# City of Richmond

## Report to Development Permit Panel

**File:** DP 18-825663

**Re:** **Application by Billard Architecture for a Development Permit at  
2660 Smith Street**

A2.50  
SHEET NO.  
3.115" = 1" C.R.  
DRAWN BY: CC

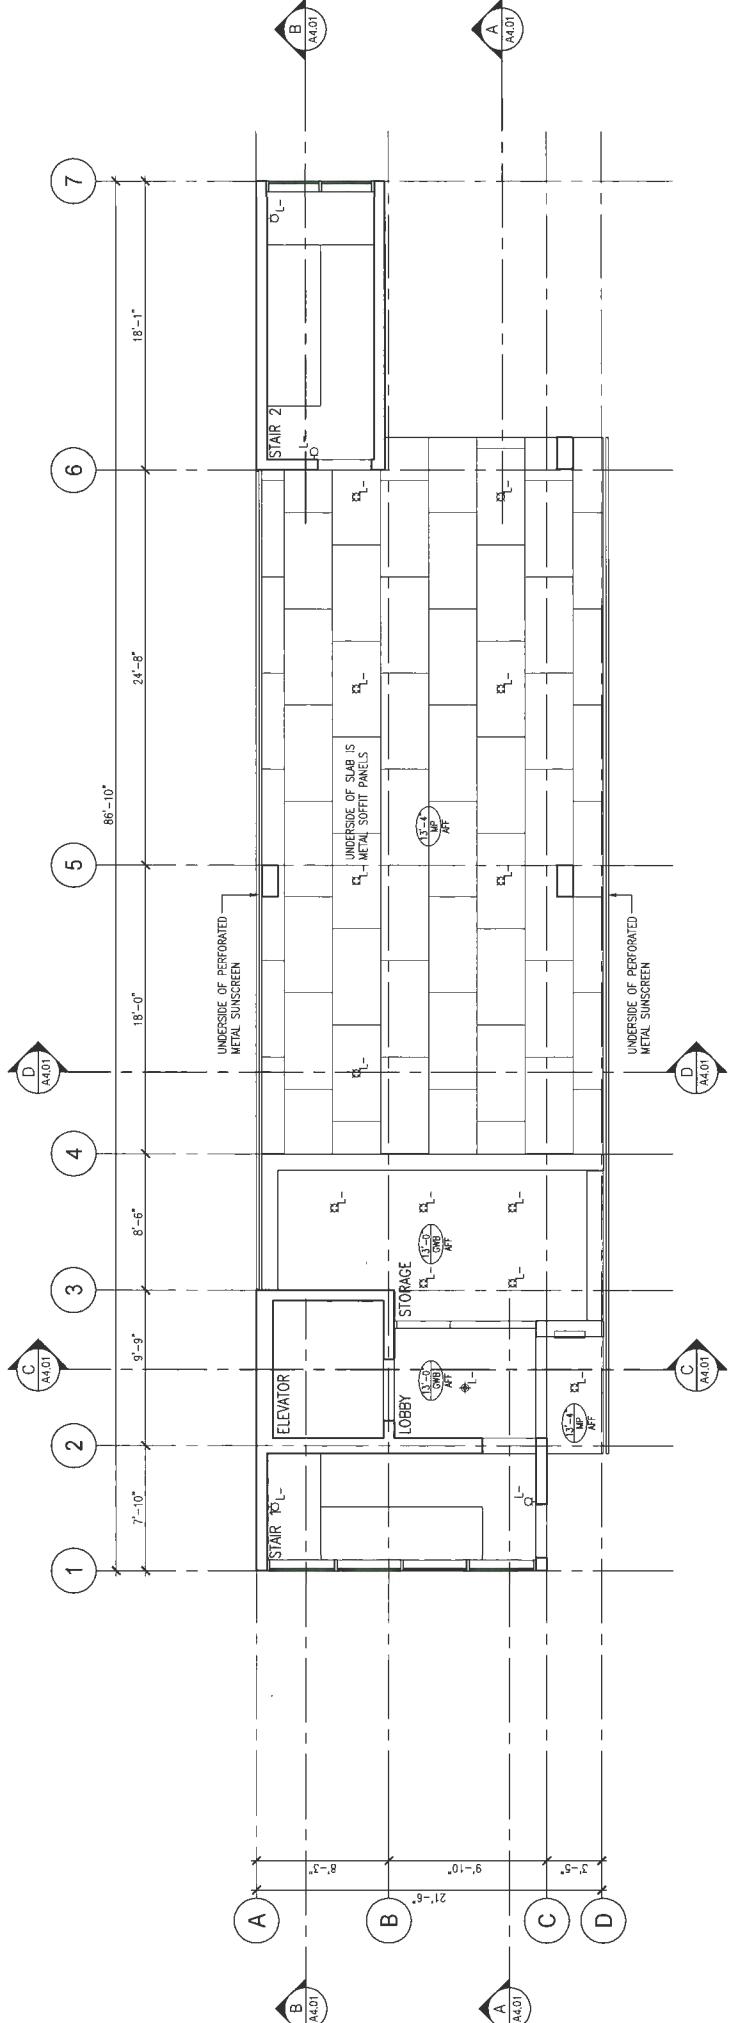
- identify the soffit material and provide a lighting plan due to the soffit's visibility from around the building;

*Addressed. See drawing A2.40. Metal soffit panels to be used in the parking area. Lighting layout provided.*

1 SCREEN FENCE ELEVATION  
A7.01 1/2'=1'-0"

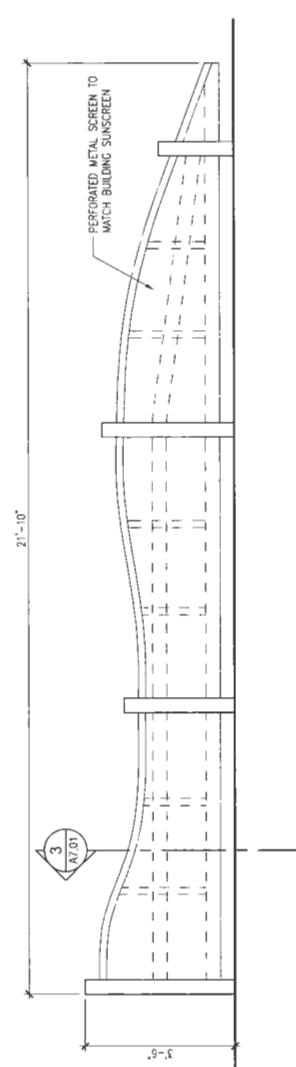
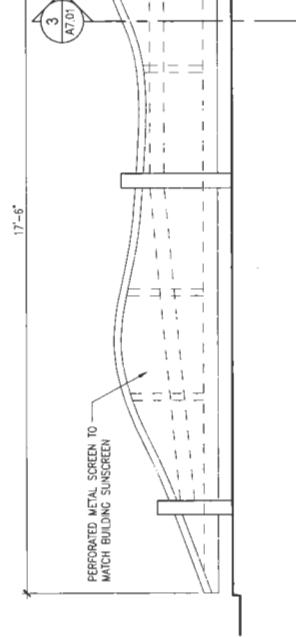
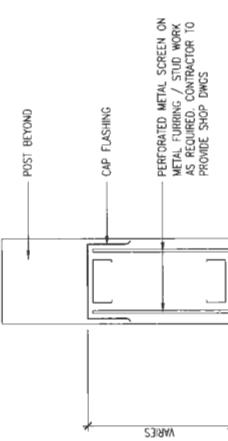
- the six-inch wide planting bed between the multi-use path and loading space will not work as it lacks the necessary size;

- the loading space separated from the multi-use path by a very narrow planting strip poses a safety issue for pedestrians; also consider installing a physical barrier between the loading space and the proposed pedestrian-oriented plaza for pedestrian safety; safety provisions on the ground level should also be considered for pedestrians coming out from the exit stairs, e.g. installing bollards or different paving treatment;

*Addressed. See drawings A1.00, A2.10, and A7.01. Planting bed removed. Added perforated metal fence between multi-use path and loading space. Details provided.*

*Addressed. See drawings A1.00, A2.10, and A7.01. Added perforated metal fence between multi-use path and loading space. Light bollards proposed between loading space and entry plaza to provide physical barrier to pedestrian-oriented plaza. Details of perforated metal fence provided.*

SCALE: AS NOTED  
DRAWN BY: CC  
CHECKED BY: RB  
FILE: 18BA08  
**A7.01**

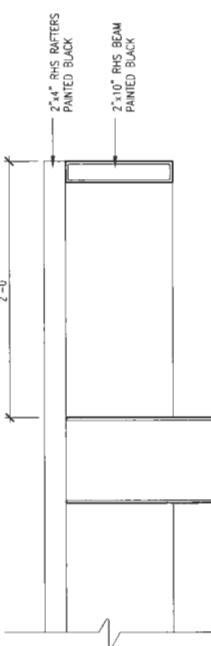
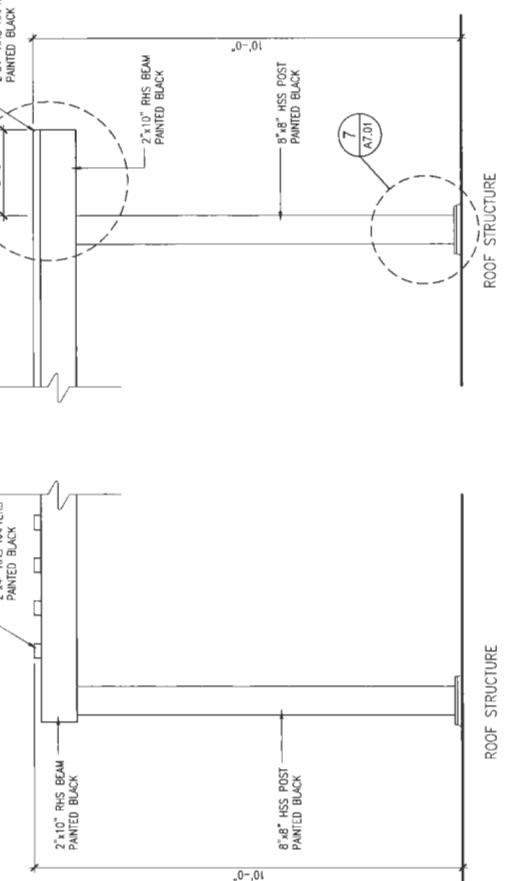
- wood trellis on the roofdeck is not consistent with the proposed building materials; consider using metal for the trellis to fit in with the building architecture;

*Addressed. See drawings A2.30, A3.01, A3.02, and A7.01. Black metal trellis to be used instead of wood. Details provided.*
